November 9, 2018

Heartland Warranty 2831 Dexter DR Elkhart IN 46514

In an effort to clarify the warranty procedure so that information can be accurately reported, and create as little confusion as possible please follow the following Guidelines in completing this recall.

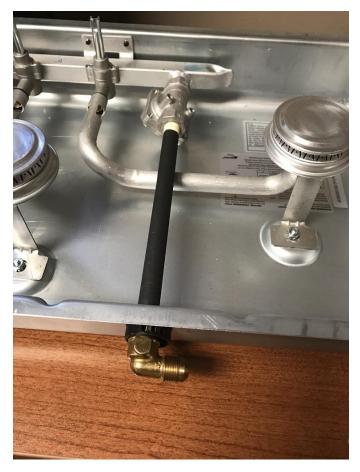
With an adjustable or open ended crescent wrench, disconnect the flex line from the flared coupler, as well as the coupler from the cooktop manifold.

The coupler can be discarded as it will not be used for the corrective action.

Pull the flex line out of the back of the burner box through the black grommet.

The image to the left is the supplied piece which will replace the flared coupler and create a rigid pipe section throughout the entire burner box of the 2 burner cooktop. The 90 degree elbow will be oriented outside of the cooktop burner box.
